# Technical Service Information

## **THM 4T60-E COMPLETE HYDRAULICS CHANGE FOR 93-94**

Figure 8

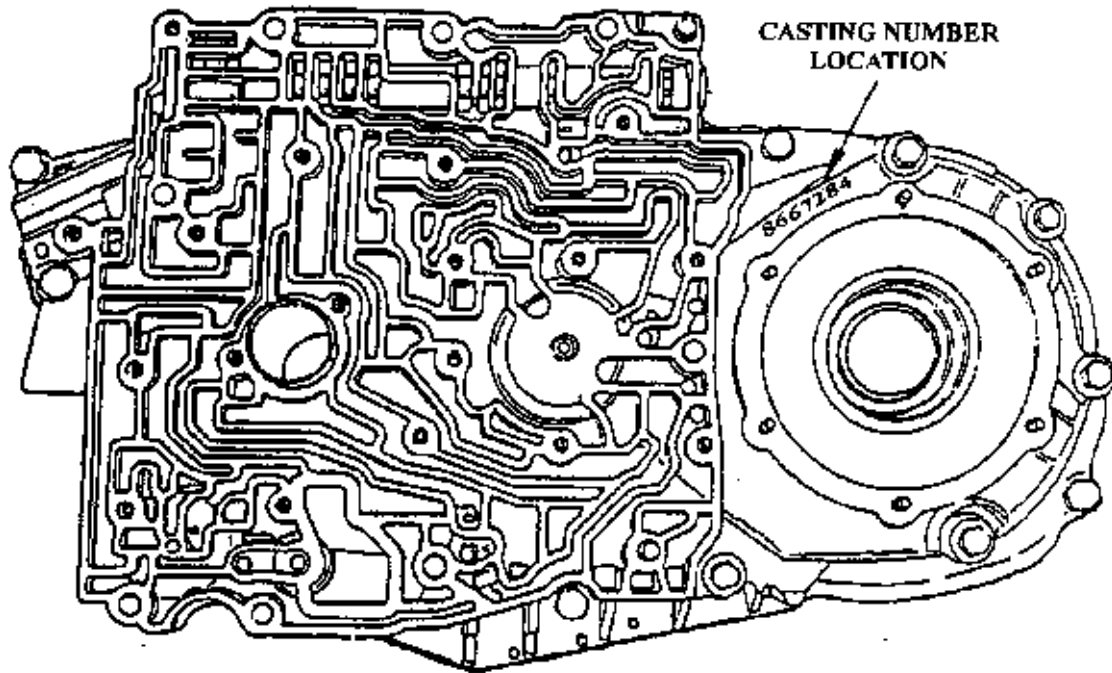
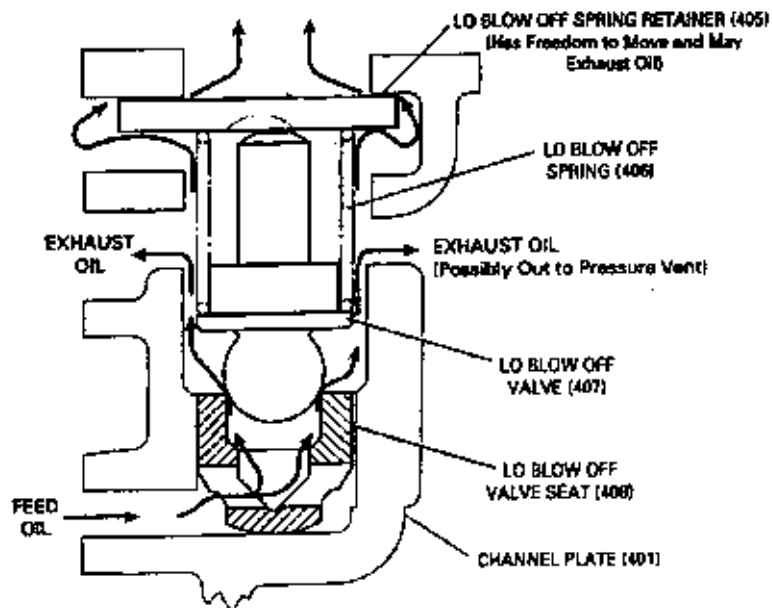
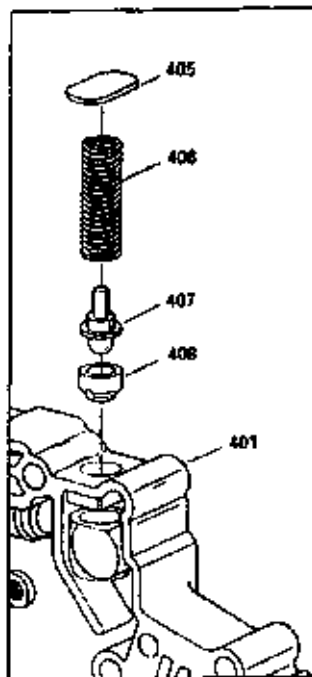
(4) **CHANNEL PLATE ASSEMBLY** - There are casting changes in the worm track area to accommodate the valve body changes, as shown in Figure 7. The Channel Plate can be easily identified by the casting number. Refer to Figure 8 for casting number location. The casting number for the 91-92 hydraulics is 8667284, and casting number for the 93-94 hydraulics is 8682217, and is shown in Figure 8. There was also a change in the Lo Blow Off Valve and Seat, which is also located in the channel plate. These changes are shown in Figure 9.
